Re: Peer Review Comment Response
444 East Central Street, Franklin, MA

Goddard Consulting, LLC, (Goddard) is pleased to submit this response letter on behalf of TAG Central LLC (the Applicant), to provide responses to the peer review comments issued by BETA Group, Inc. regarding the Abbreviated Notice of Resource Area Delineation (ANRAD) application filed for 444 East Central Street.

Re: Response to MassDEP Comments
444 East Central Street, Franklin MA (DEP File #159-1306)

DRAWING TITLE: **IWW EXHIBIT** SHEET No. **EX-1**

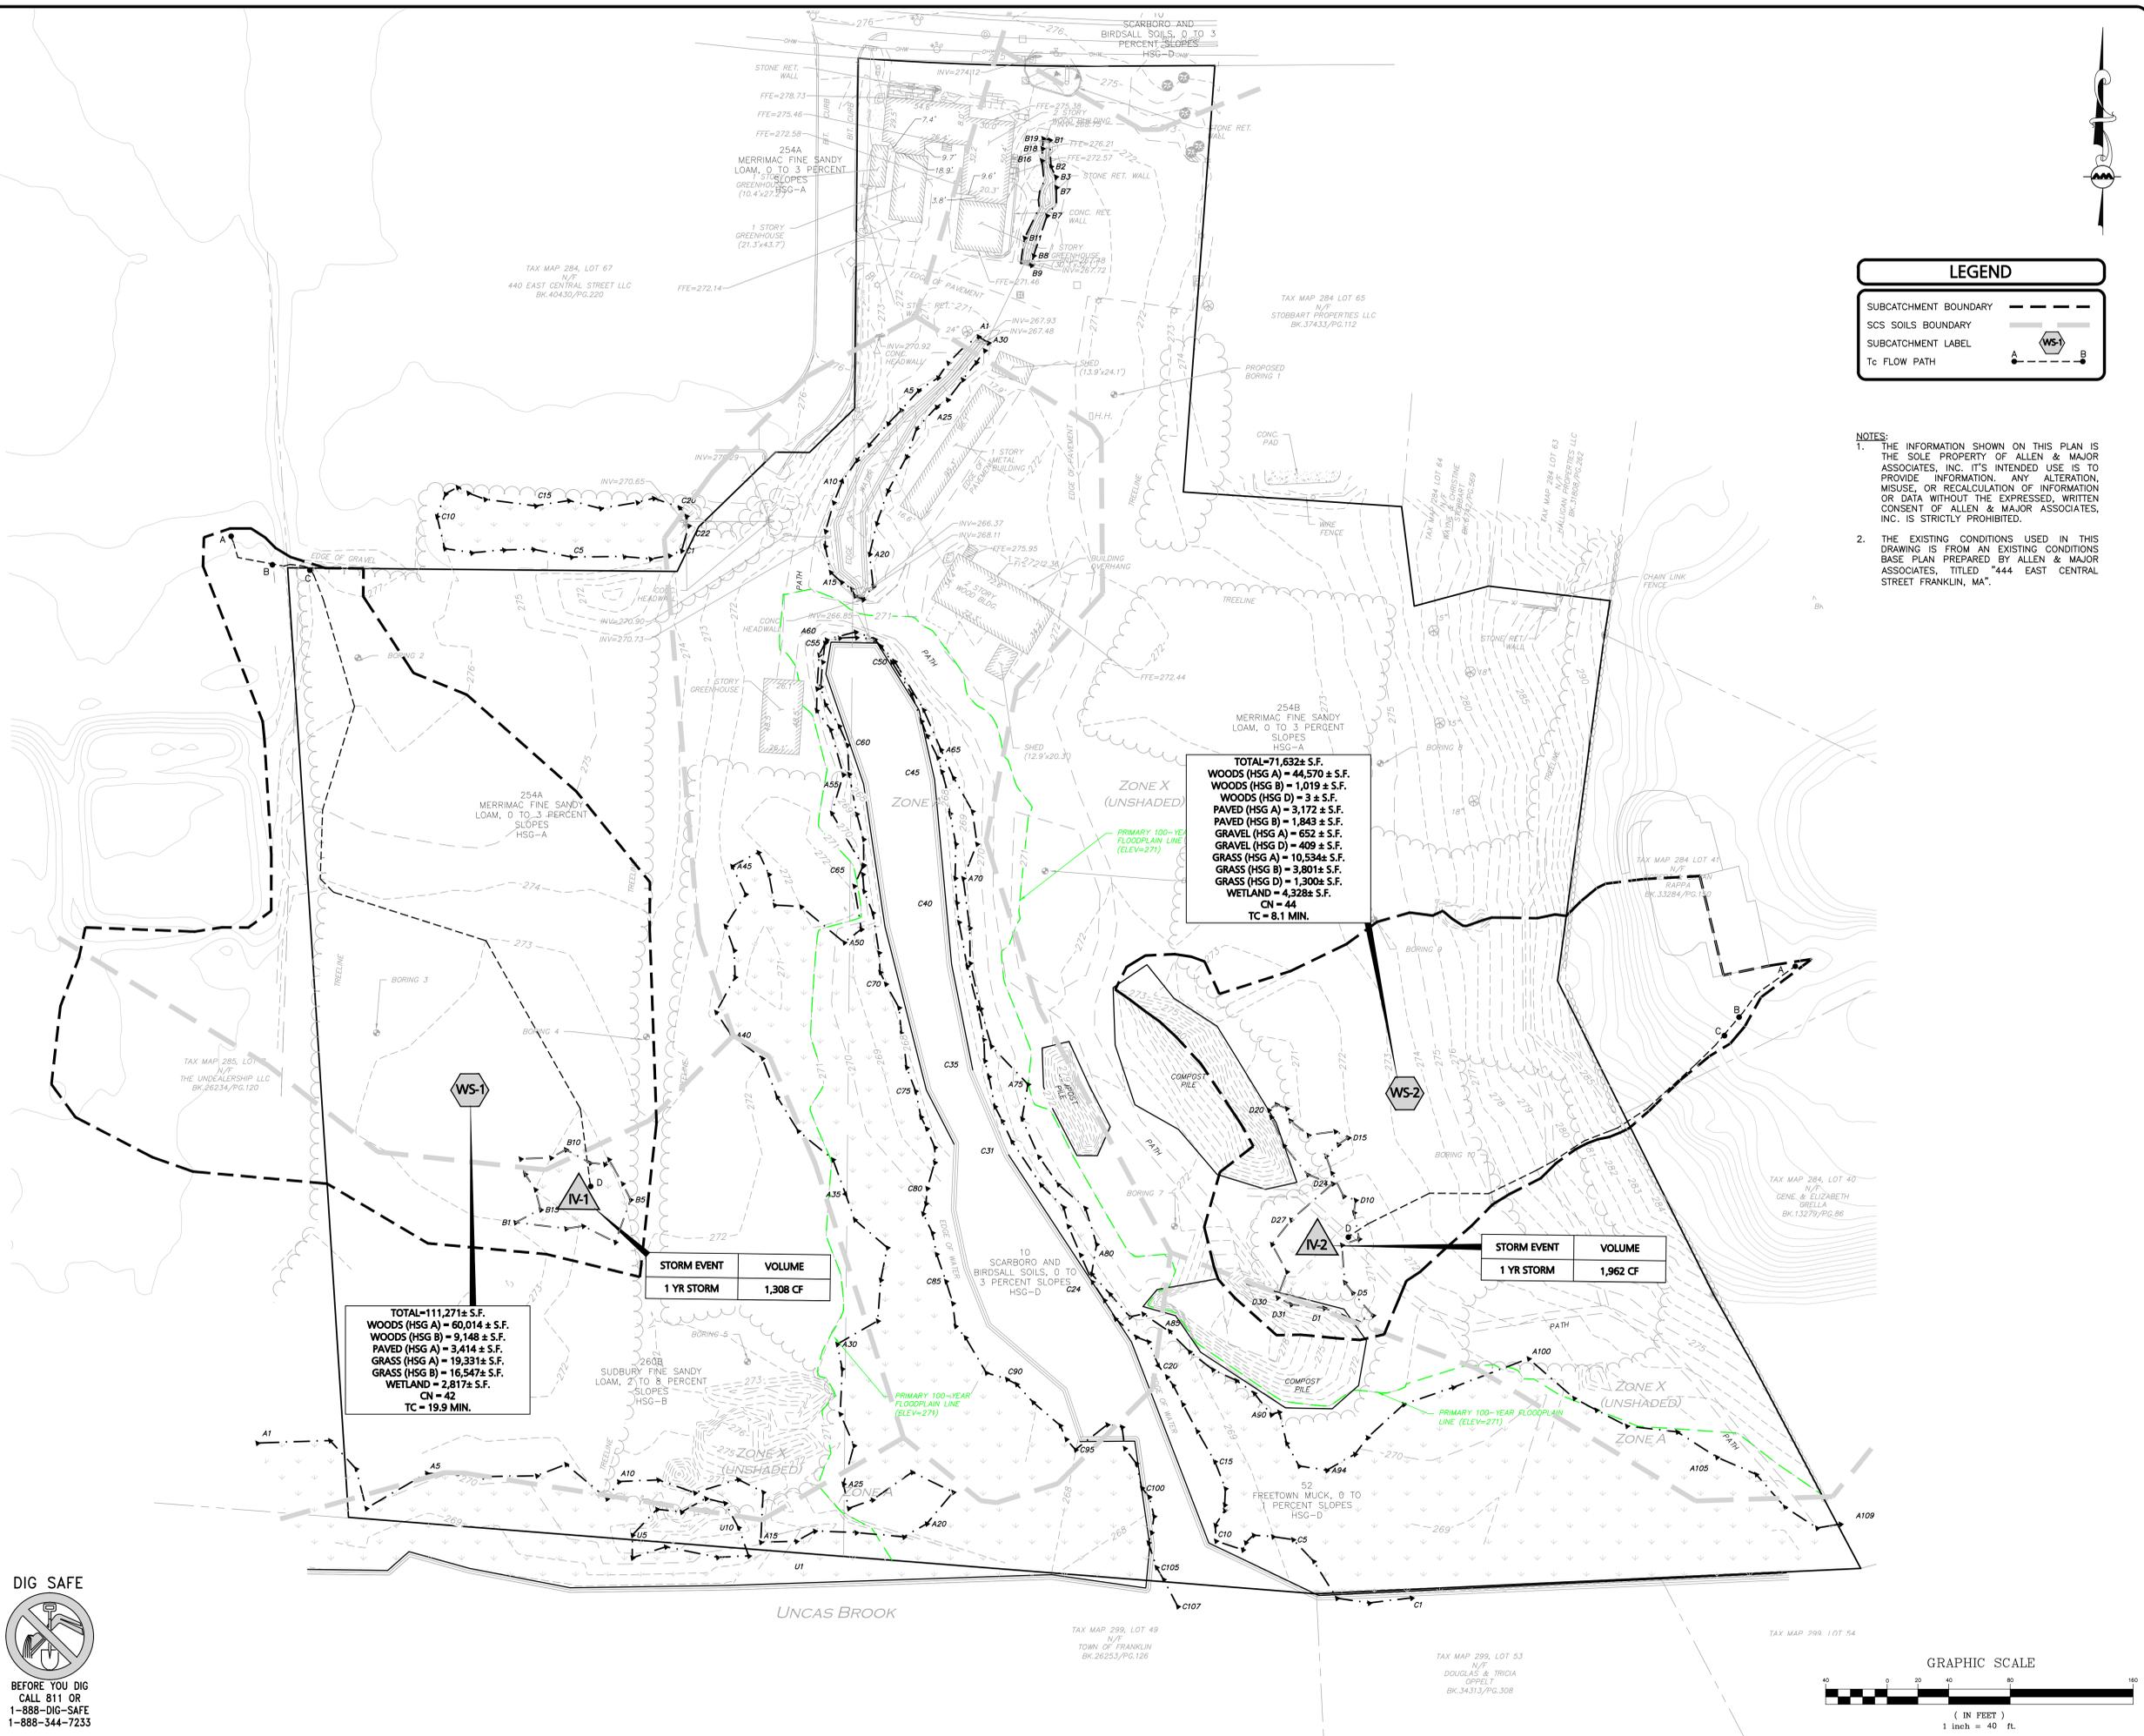
#5	The Applicant should submit the required calculations to determine the presence of ILSF within the B-, C-, and D-Series IVWs if they seek confirmation of the absence/presence of ILSF. Should these calculations not be provided, the Commission should note in the ORAD that ILSF is not confirmed as part of this filing.	ILSF calculations were previously submitted to the Commission in a letter titled <i>Response to MassDEP Comments, 444 East Central Street Franklin MA (DEP File No. 159-1306)</i> , prepared by Goddard Consulting LLC, dated January 2, 2025. This letter is also included as an attachment herein. The Applicant does seek confirmation that no ILSF is present on the locus site as demonstrated in the calculations provided by A&M in that letter.

#2	<p>The Applicant should provide additional information in accordance with 310 CMR 10.57(2)(b)3. to verify whether the isolated vegetated wetlands meet parameters to be considered isolated land subject to flooding and jurisdictional under the WPA.</p> <p>Additionally, if the Applicant suspects that the isolated wetlands were once stormwater management features, additional information in accordance with 310 CMR 10.02(2)(c) should be provided to MassDEP and the Commission demonstrating when the basin was installed and that the stormwater basin has been maintained as such. The Commission may request that the Applicant submit maintenance logs. MassDEP recommends the Commission should verify that the GCC series does not connect to the wetland system. If a connection does exist, based on the information provided the GCC series may be considered jurisdictional even if it was a stormwater basin previously. Please provide additional information accordingly.</p>	<p>A&M has prepared engineering calculations to confirm that the isolated vegetated wetlands are not capable of containing ¼-acre foot of water and therefore cannot qualify as Isolated Land Subject to Flooding (see attached IVW Exhibit and HydroCAD calculations).</p> <p>It does not appear that either of the on-site IVWs (GCB- or GCD-series) were constructed as stormwater basins.</p> <p>Goddard and A&M do believe that the GCC-series wetland was constructed as a stormwater basin, but it does not appear to have been maintained due to the presence of large woody vegetation. As such, it has been identified as a vegetated wetland to accurately display the 100-foot buffer zone that casts onto the locus site. Goddard and the Applicant are investigating any potential connection and will provide revised plans to the Commission and MassDEP as appropriate.</p>

STORM EVENT	VOLUME
1 YR STORM	1,308 CF

STORM EVENT	VOLUME
1 YR STORM	1,962 CF
